NPDES RGP PERMIT APPLICATION
TEMPORARY CONSTRUCTION DEWATERING
341 SECOND AVENUE
WALTHAM, MASSACHUSETTS

Subject: NPDES RGP Permit Application – Temporary Construction Dewatering
341 Second Avenue
Waltham, Massachusetts

RESPONSE TO PUBLIC COMMENTS REGARDING MASSDEP'S TENTATIVE DETERMINATION TO ISSUE AN ANTIDegradation AUTHORIZATION TO DISCHARGE TO AN OUTSTANDING RESOURCE WATER

Subject: Response to MassDEP Questions
Re: NPDES Remediation General Permit Application
341 Second Avenue
Waltham, Massachusetts

Figure 2: Drawing C-103.1 Grading & Drainage Plan (by Allen & Major Associates, Inc.)

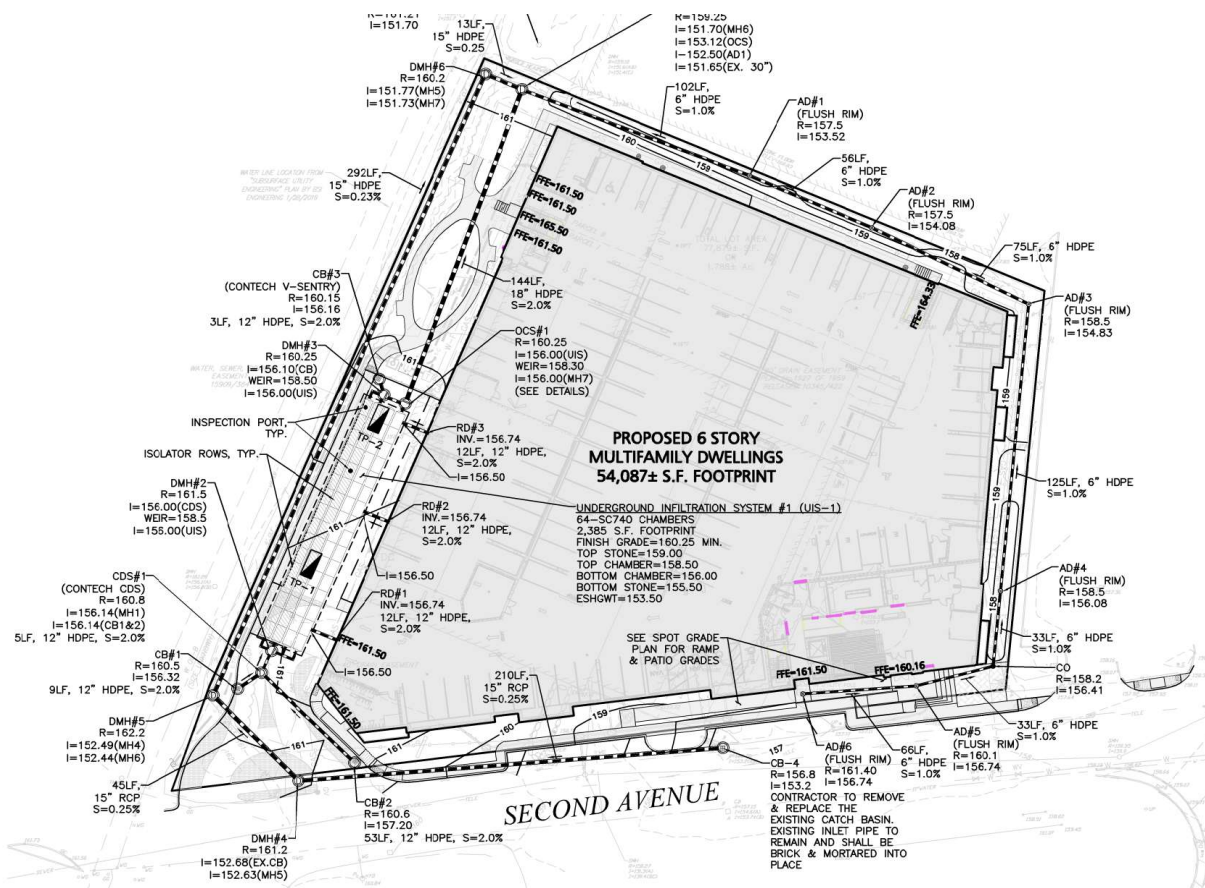
2. *Can a portion of the discharge be infiltrated, and could you provide supporting information on the soil condition to support any claim of the volume that can (or cannot) infiltrate?*

After reassessing all the options, the hydrogeologist and engineering teams have determined that limited infiltration is feasible. As a consequence, we have **made plans to install the permanent stormwater infiltration gallery (shown on Figure 2) prior to the building excavation, in order to allow for the infiltration system to be used to recharge a portion of the dewatering effluent during construction.** This sequencing had not previously been planned since the location of the infiltration gallery is at the main entrance to the construction site and is a necessary construction staging area; special precautions will be necessary above the newly constructed infiltration gallery to protect it from damage by the loads of heavy construction cranes and other equipment during construction.

Figure 6:

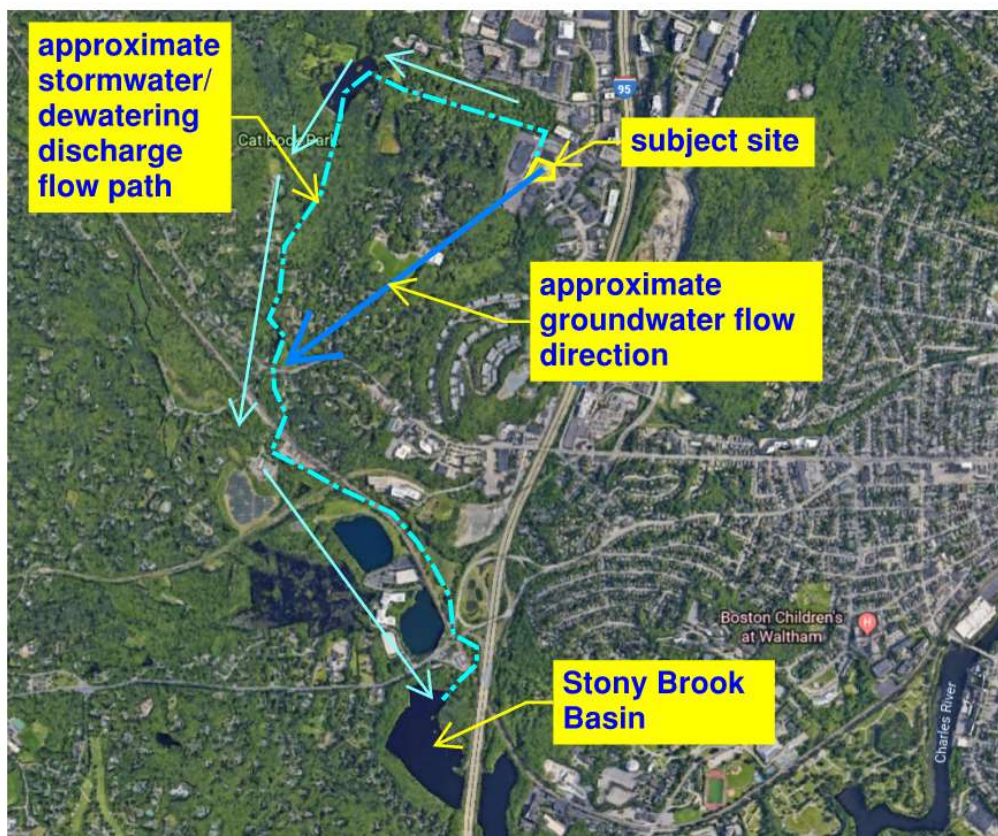
6. *Could you provide hydrology of groundwater flow in this area and whether the hydraulic gradient of the groundwater at the site is flowing to the Stony Brook Reservoir and/or its tributaries?*

The site is located within the Stony Brook watershed. Based on groundwater elevations measured within on-site observation wells, the predominant direction of groundwater flow is toward the south and southwest. Groundwater flow is coincident with general site topography, and to some extent is regionally controlled by the bedrock elevations in the area. Bear Hill located south of the site is a rock-controlled hill, and to the east there are rock outcrops along Route 128. These regional features result in the groundwater flowing along the bedrock valley within the permeable glacial deposits. Surface water and groundwater flow from the site is toward wetlands and ponds located south of the site that connect into Hobbs Brook that discharges into Stony Brook near Church Street and North Avenue (Rte 117) intersection.

Dewatering effluent discharge at the site will also flow toward the tributaries of the Stony Brook Reservoir, as shown in Figure 6 below.
